Re: Kittery Aroma Joes | Site Plan Peer Review Comments

Haley Ward, Inc. (Haley Ward) has prepared the following response to the review comments on the 523 US Route 1 Aroma Joes development, provided by Jodie Strickland (CMA Engineers) on April 19, 2022. The comments have been provided in bold italics, followed by our response.

TITLE				
PROPOSED SITE AND UTILITIES PLAN

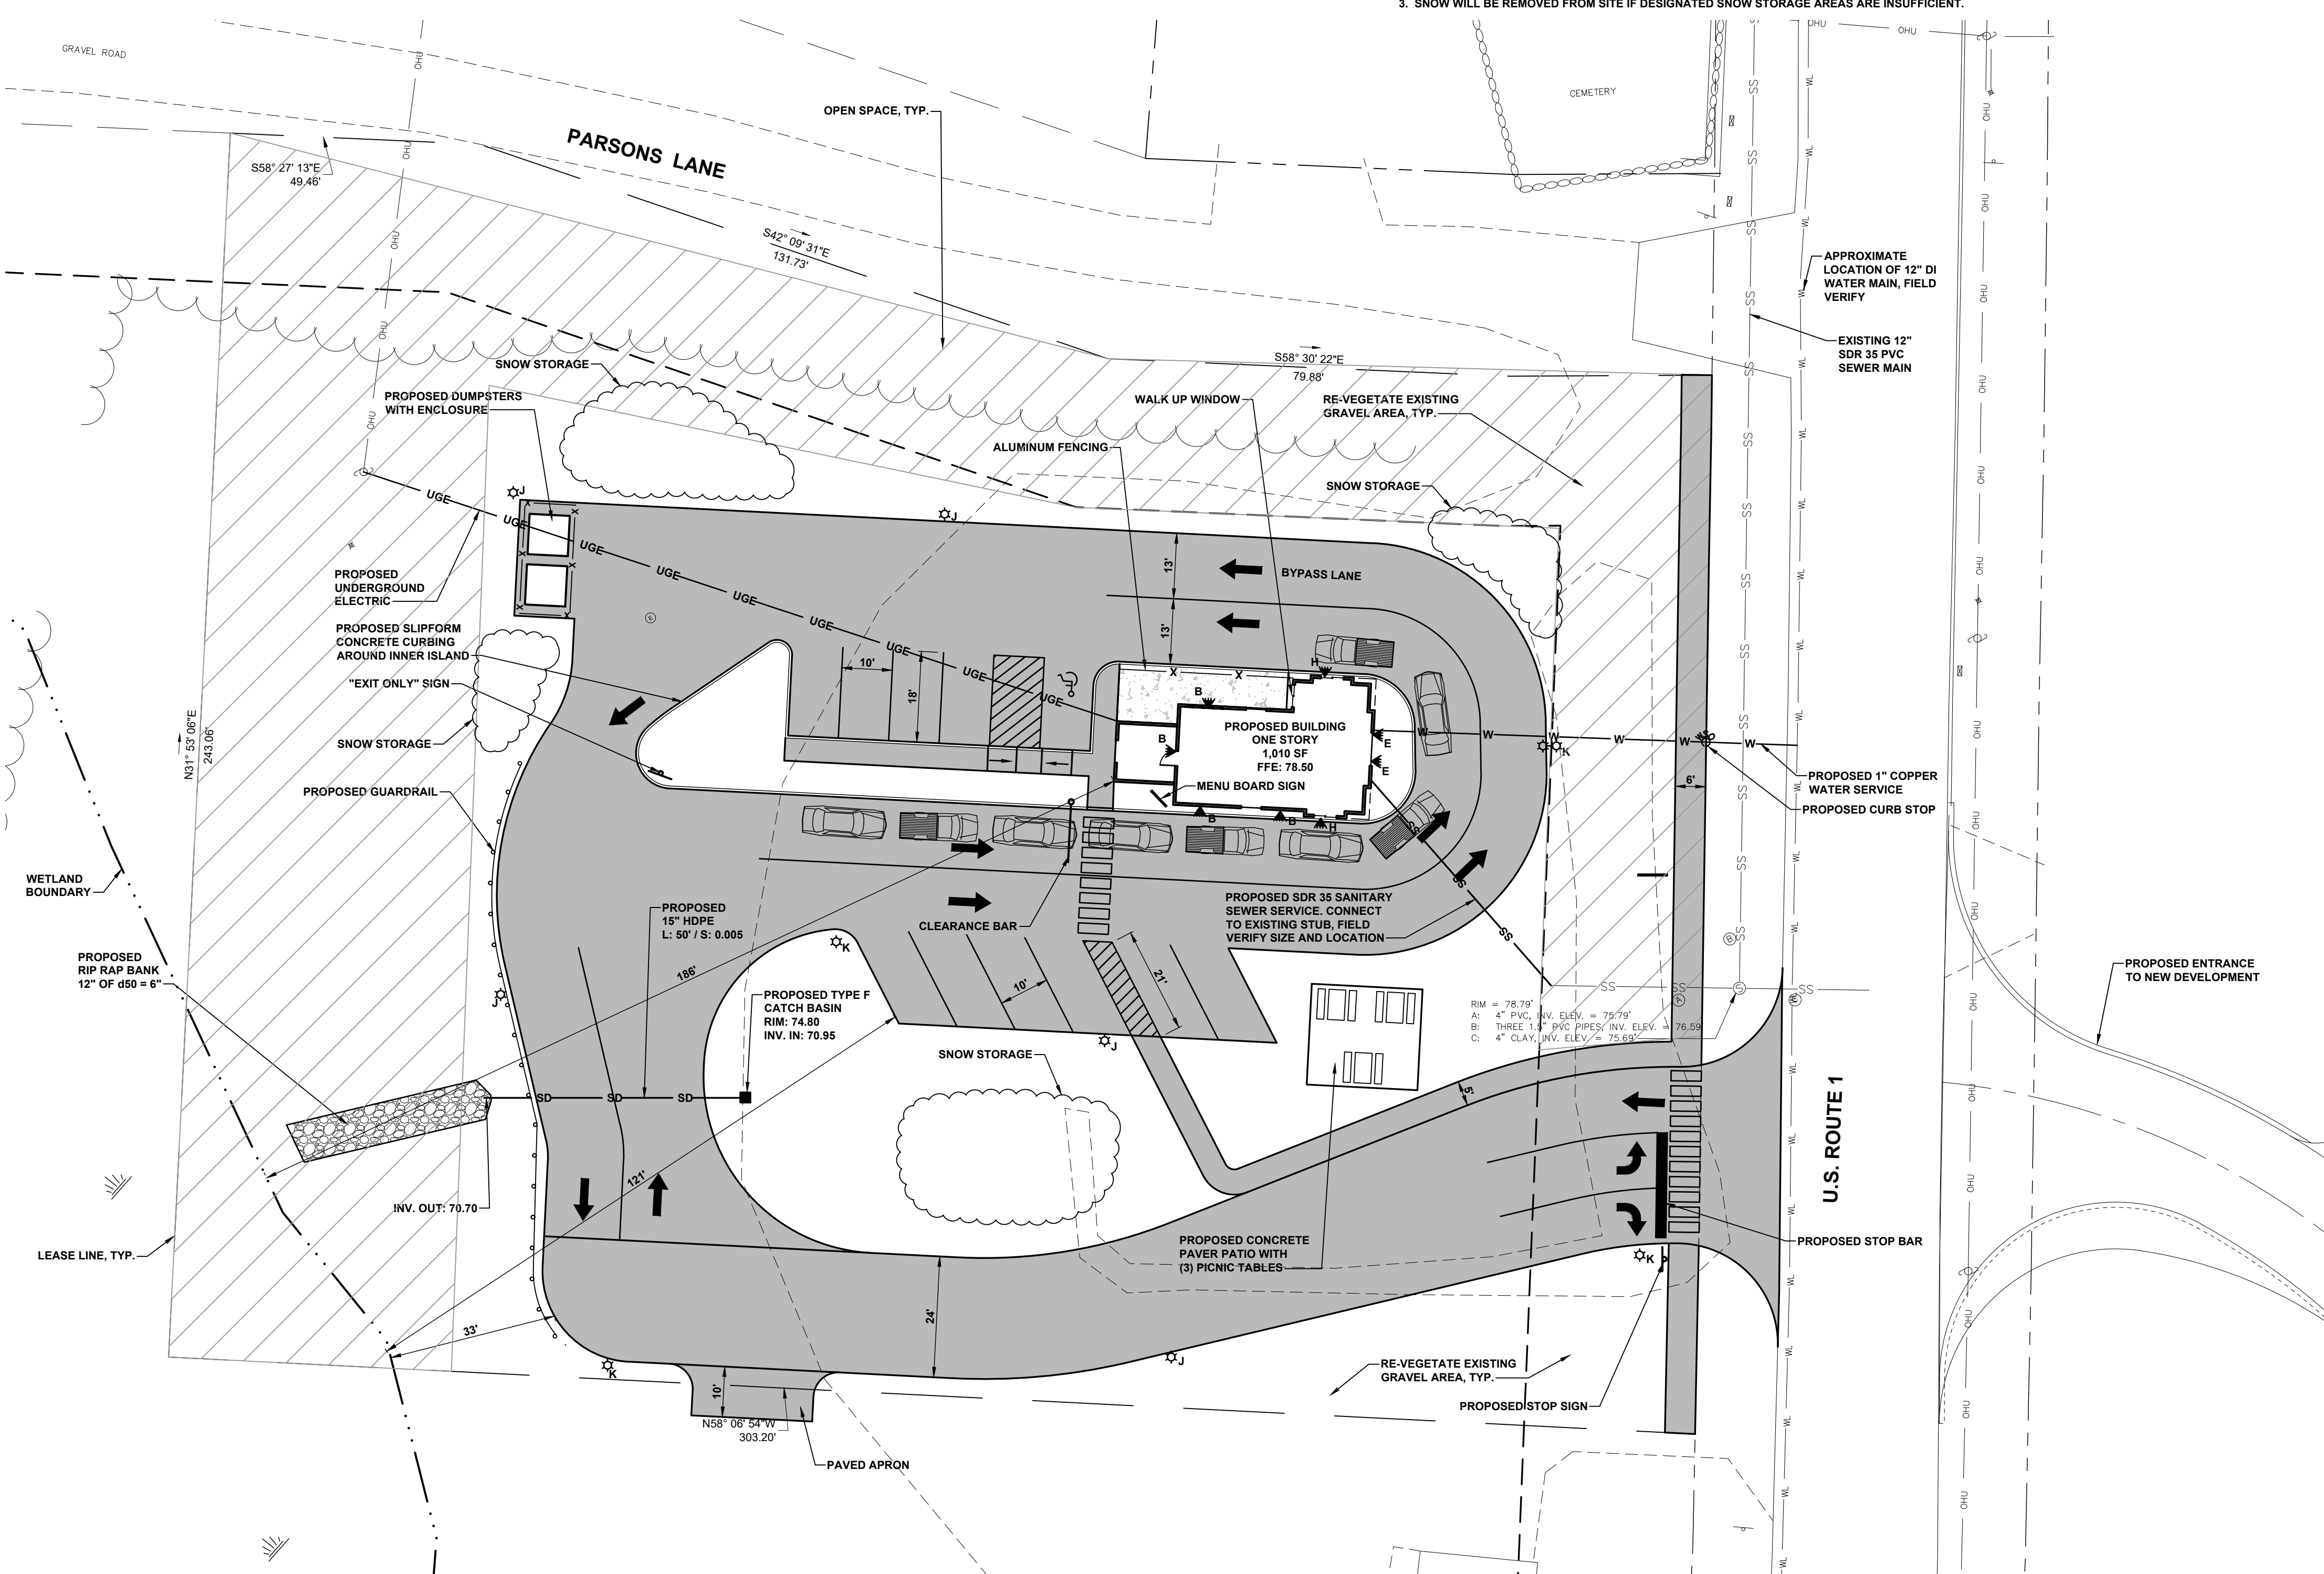
10. **The plan identifies wetlands. Site development and disturbance appears to avoid the setbacks associated with the wetlands however, the proper setbacks should be indicated on the plan.**

11. **The size of the wetland is not indicated but based on the setbacks shown it is assumed that it is larger than 1 acre in size. The applicant has shown the provided setbacks for the building (100' from a wetland > 1 acre) and the driveway (30' from a wetland > 1 acre) however, there are no parking area setbacks shown on the plans. The setback from a wetland greater than 1 acre for a 6-10 stall parking area without BMPs is 100', it appears that the southern-most parking area may be within the 100' setback. Please clarify.**

These setbacks have been added to the plans.

The parking area on the south side of the building is approximately 120' away from the wetland; this setback has been added to the plan.

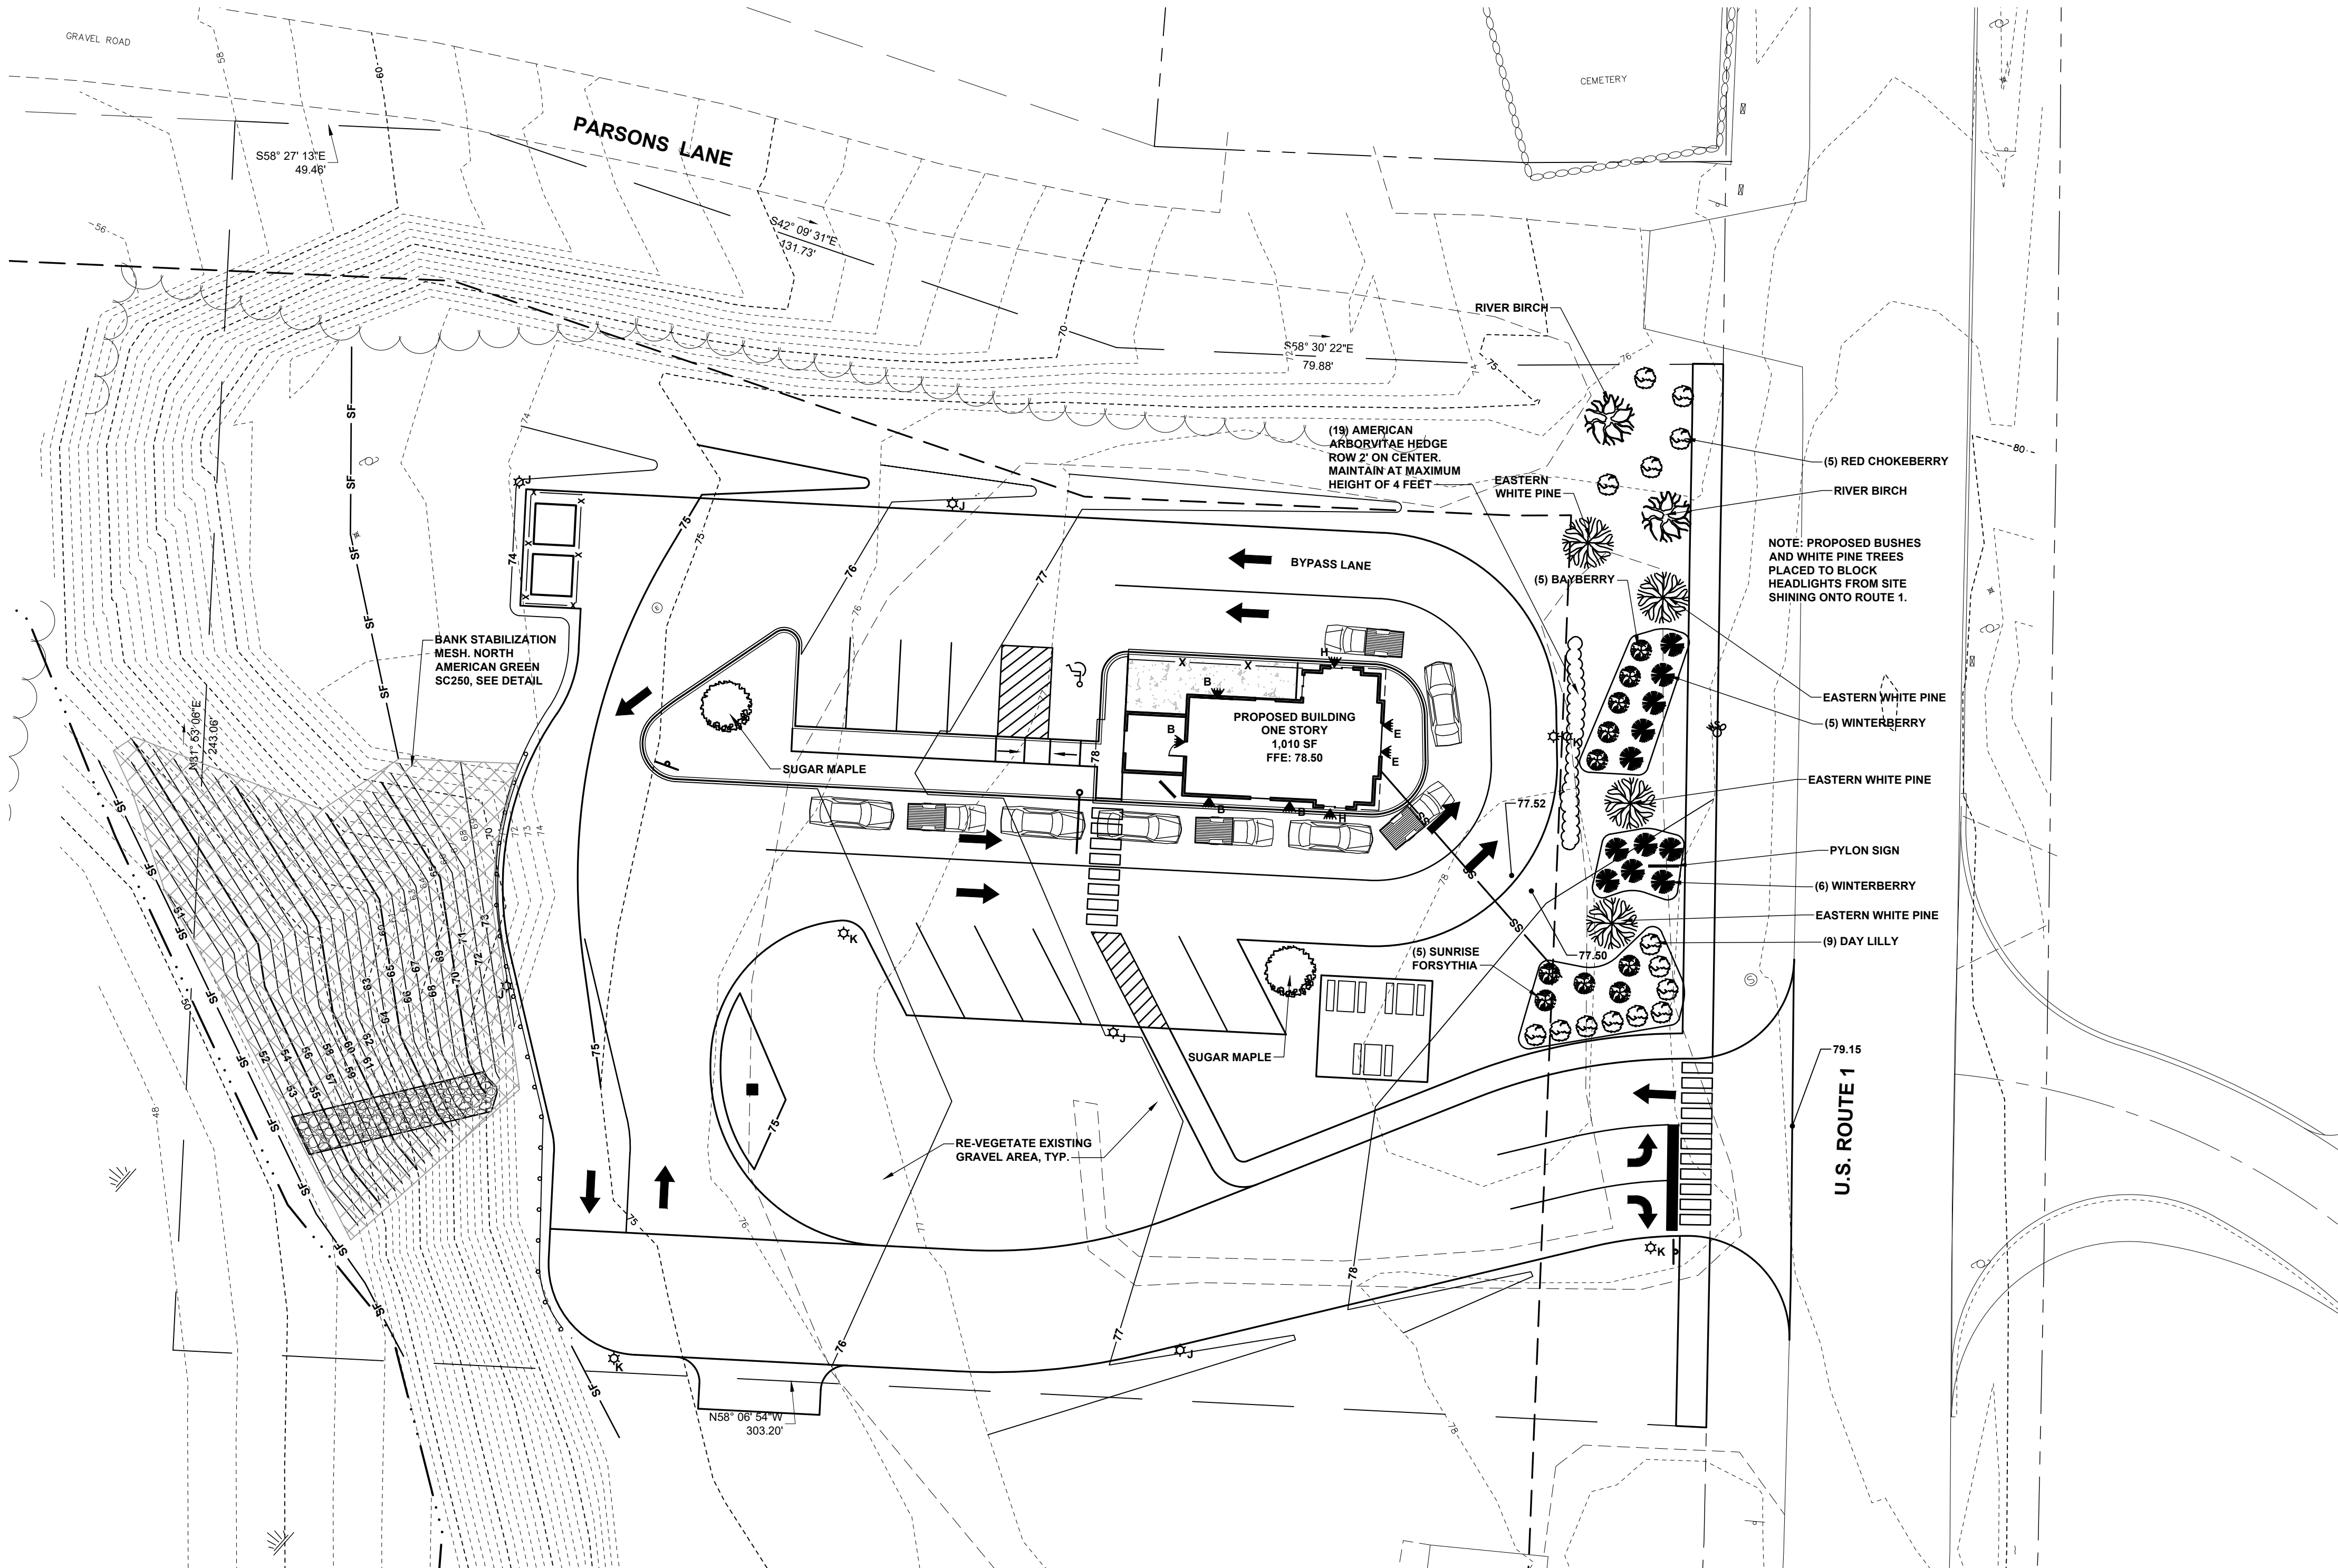
The applicant should indicate how the project is proposed to be constructed in accordance with these recommendations. If the possibility of increased pavement maintenance remains, that should be noted on the plan and may be a condition

of approval. If the existing steep slope is not flattened, the applicant should describe how it will be maintained.

The existing slope at the southwest corner of the site has been flattened as much as possible while avoiding encroachment on the adjacent wetland. This slope will also be stabilized with erosion control matting as shown on the drawings.

TYPICAL ROADWAY/SIDEWALK BUILDUP DETAIL
N.T.S.

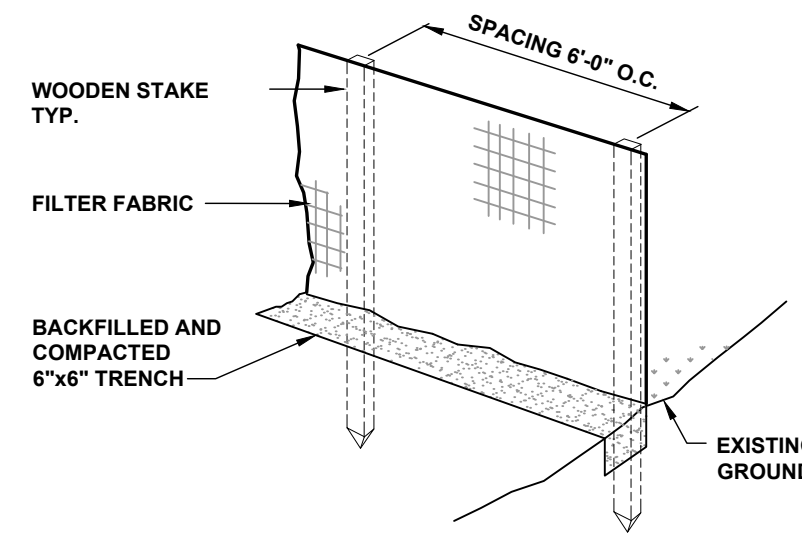
- 2. Discussion of sidewalk installation was part of the MDOT scoping meeting and consequently, the applicant has added a proposed sidewalk on site. Details of the sidewalk should be provided.***

A detail of the proposed sidewalk has been provided on the Detail Sheet.

TYPICAL WATER SERVICE DETAIL
N.T.S.

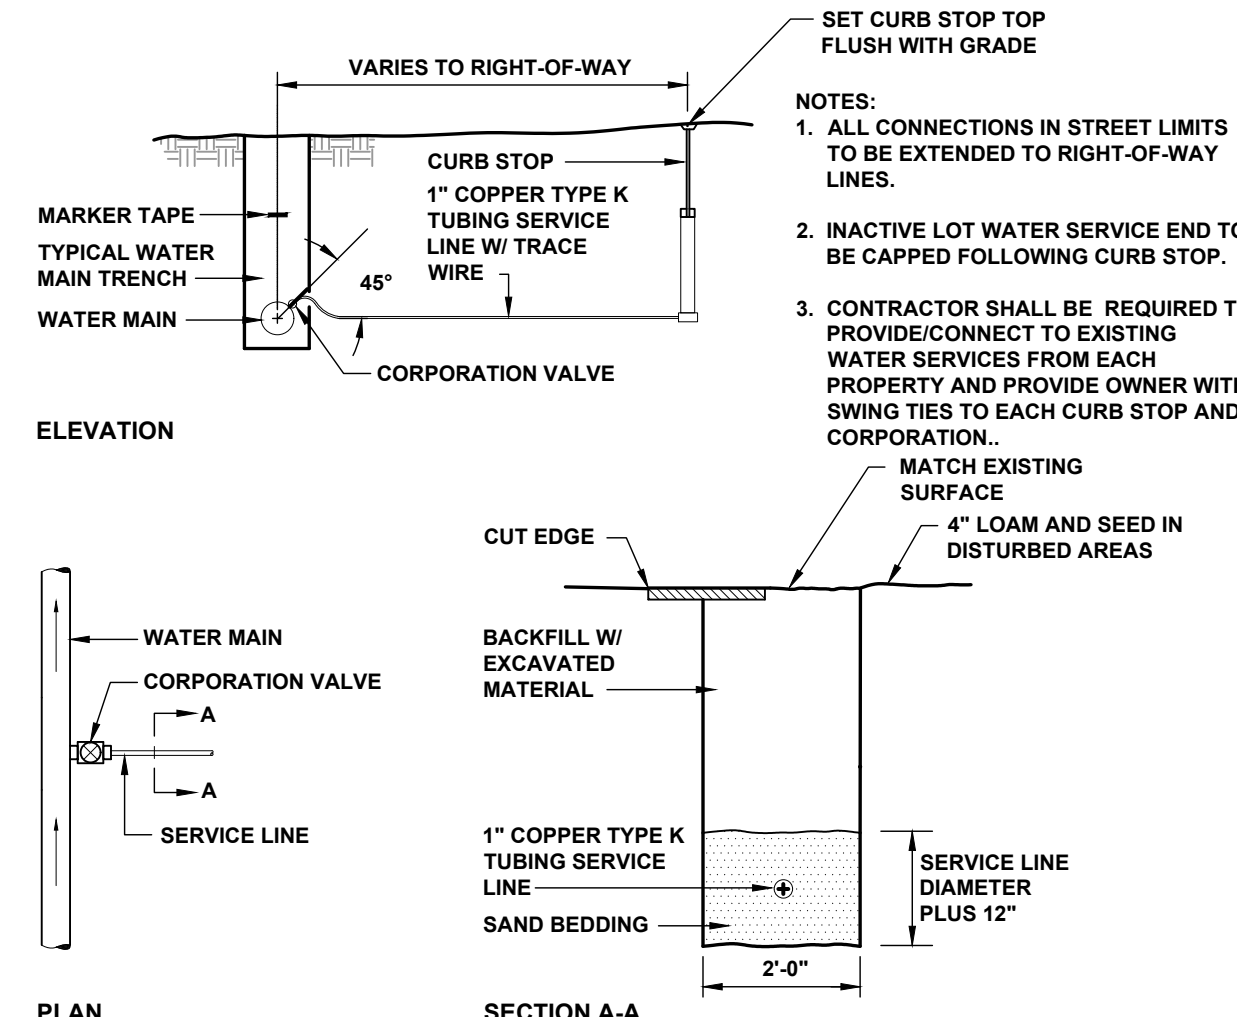
- 3. The plans should provide details for the water service (size, material, bedding, curb stop, etc.)***

A detail of the proposed service has been provided on the Detail Sheet.

TYPICAL SEWER TRENCH DETAIL
N.T.S.

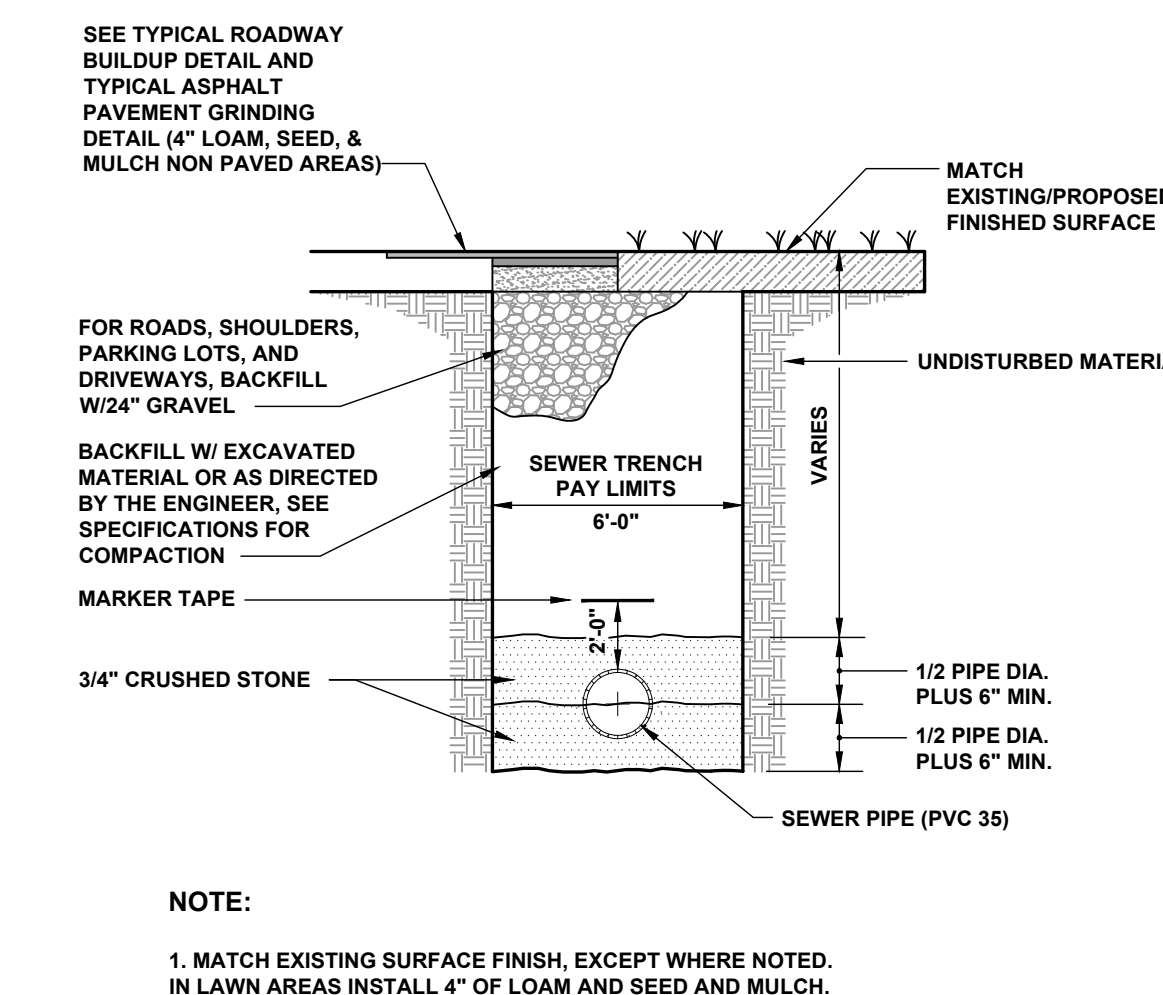
- 5. The applicant should indicate the size and material of the sewer service.**

- 6. The plans should provide details for the sewer service (size, material, bedding, etc.)**

A detail of the proposed service has been provided on the Detail Sheet.

A detail of the proposed service has been provided on the Detail Sheet.
